Objection to Planning Application DC/26/0934

Bakery Cottage, Henfield Road, Cowfold RH13 8DR

We are writing to Comment on the Planning Application DC/26/0934 “Demolition of existing vacant storage buildings and erection of 9no. residential units, provision of open space and retention of pond”

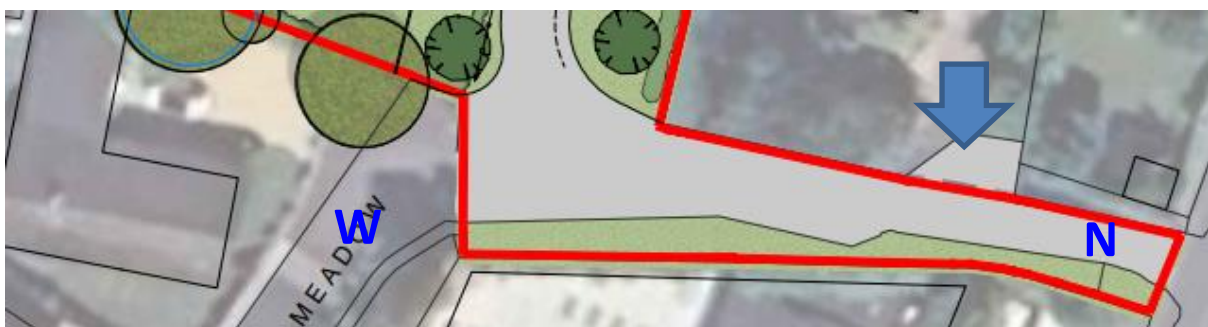
Take a look at the satellite image below and compare the width of the "housing estate road "W" with the narrow entrance "N".

Note the indentation shown on the plans in the planning application and at the entrance and arrowed below, and which looks like a parking or passing place is NOT REAL.

It is the turn into a private driveway and cannot be used as a passing or parking space.

Note again the difference in width of the narrow road allowed for in the development at the

southern end of Summer Meadow ("W") compared with the width of the entrance "N". This entrance cannot be widened. W allows two cars to pass; N does not allow two cars turning in or exiting to pass each other. Maybe it is formally within inches of being wide enough. Just try it or simply watch cars entering and exiting.

North West corner

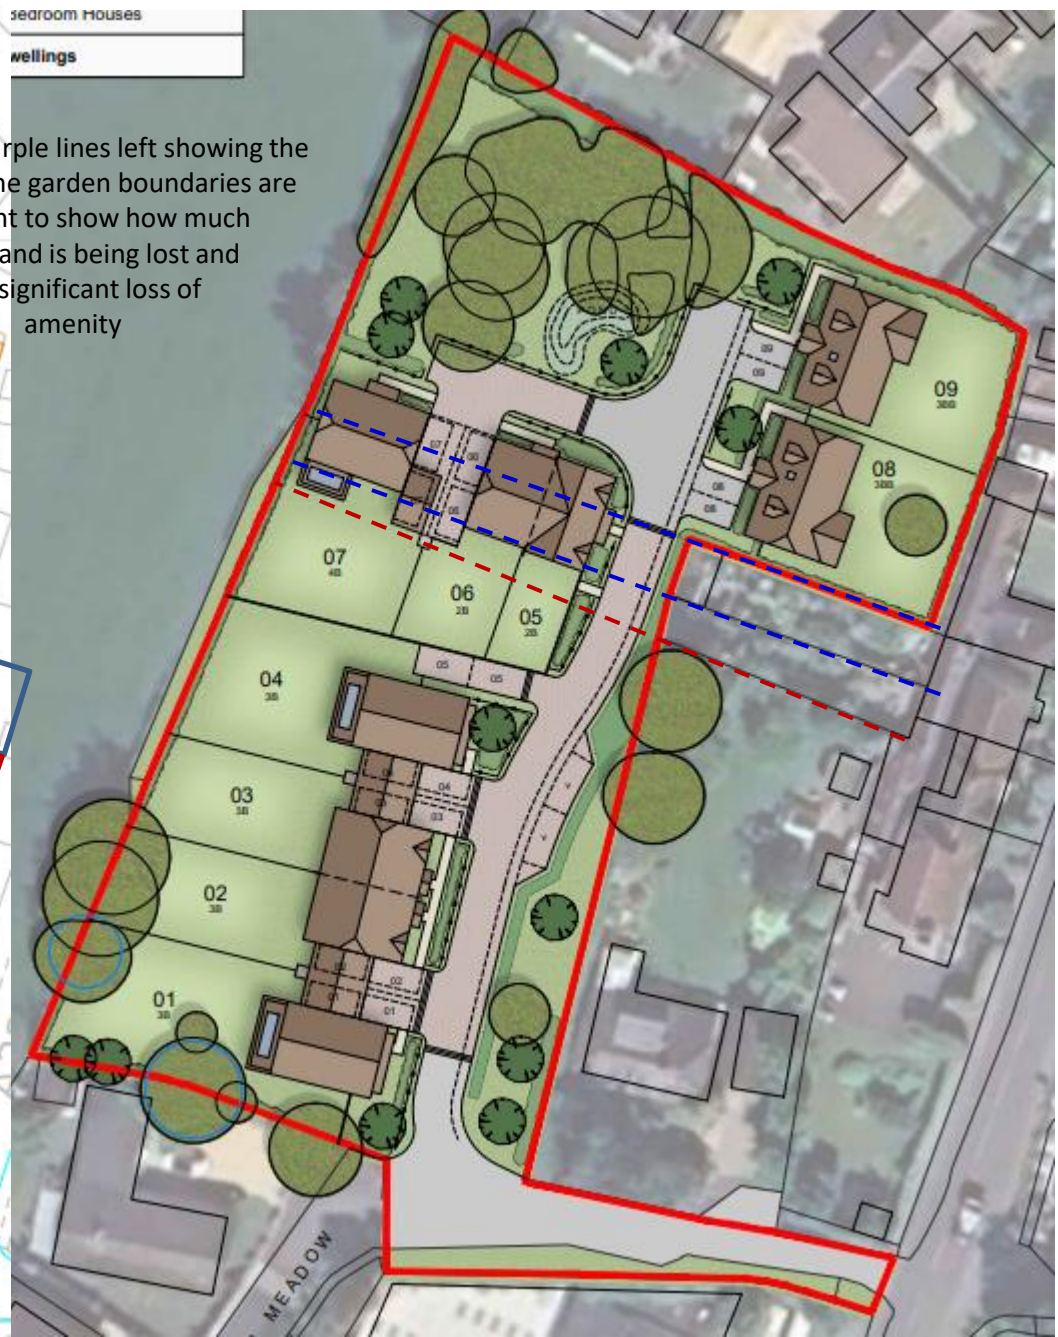
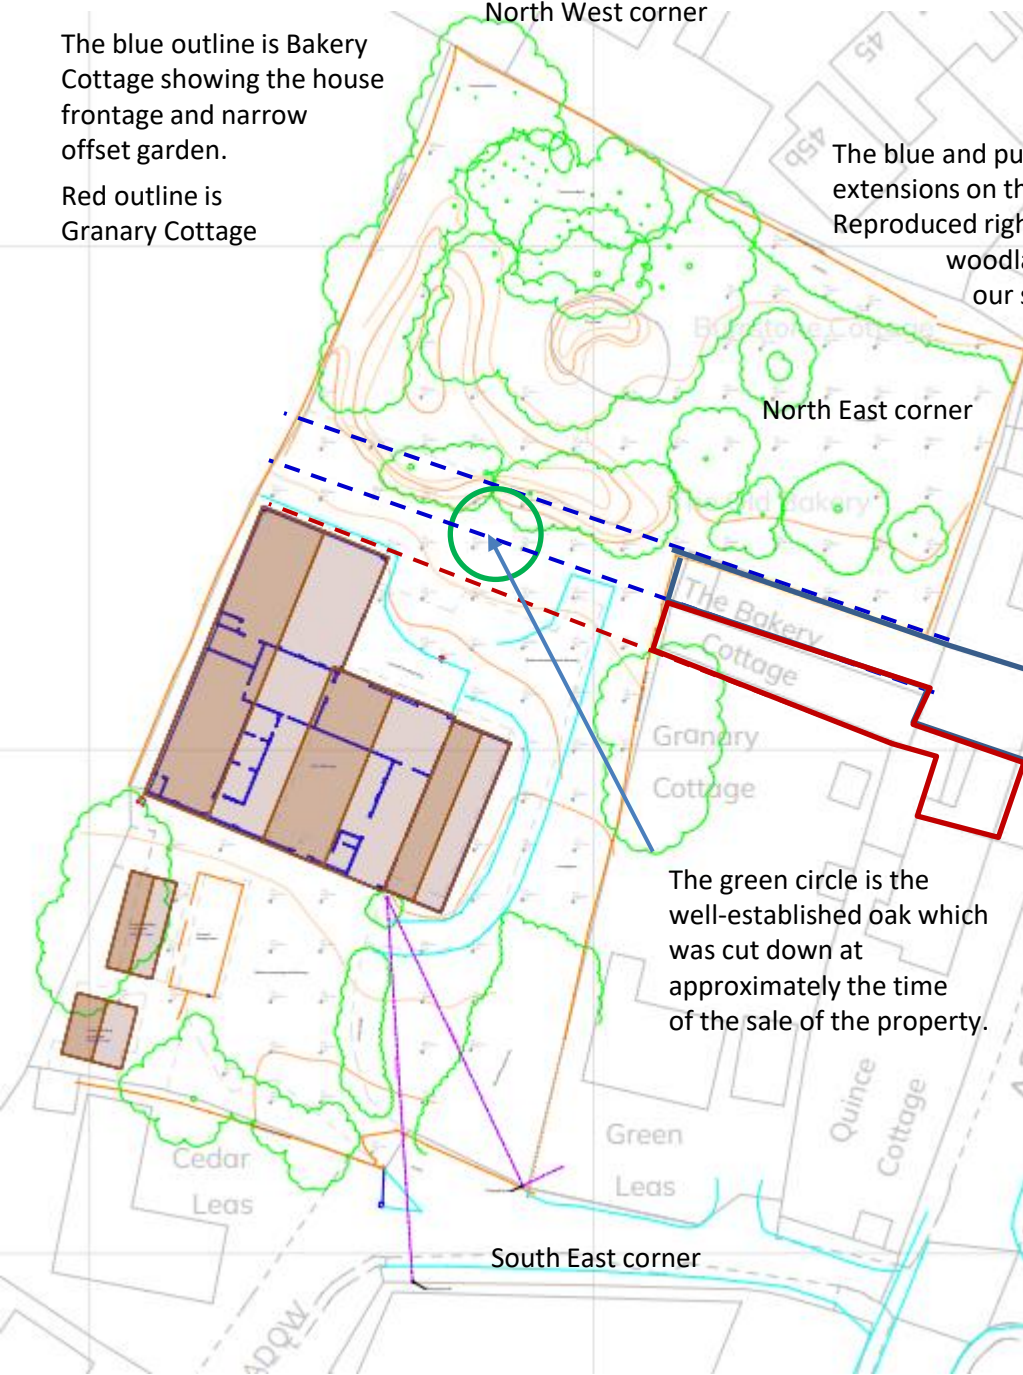
The blue outline is Bakery Cottage showing the house frontage and narrow offset garden.

Red outline is Granary Cottage

The blue and purple lines left showing the extensions on the garden boundaries are Reproduced right to show how much woodland is being lost and our significant loss of amenity

The green circle is the well-established oak which was cut down at approximately the time of the sale of the property.

To show the extent of the **loss of woodland (shaw)**, we have superimposed the proposed “accommodation schedule” as closely to scale as we can on the original topography drawing.

Under 40% of the original areas is being retained. See the third page below.

The purple arrow denotes approximately the location of a large pile of rotting wood, which formed a wonderful habitat for invertebrates and mammals. This was cleared around the time of the sale of the property, and needs to be restored there or elsewhere on the property, although it will take time for the lost wild-life to re-establish itself.

The habitat management and Monitoring plan makes a great fuss about the retention of the woodland (their description) in the SE corner of the plot.

As we can see by comparing the topography map showing the canopy in this corner with the superimposed accommodation schedule, only one small tree is being retained, the rest is cleared and two new trees planted.
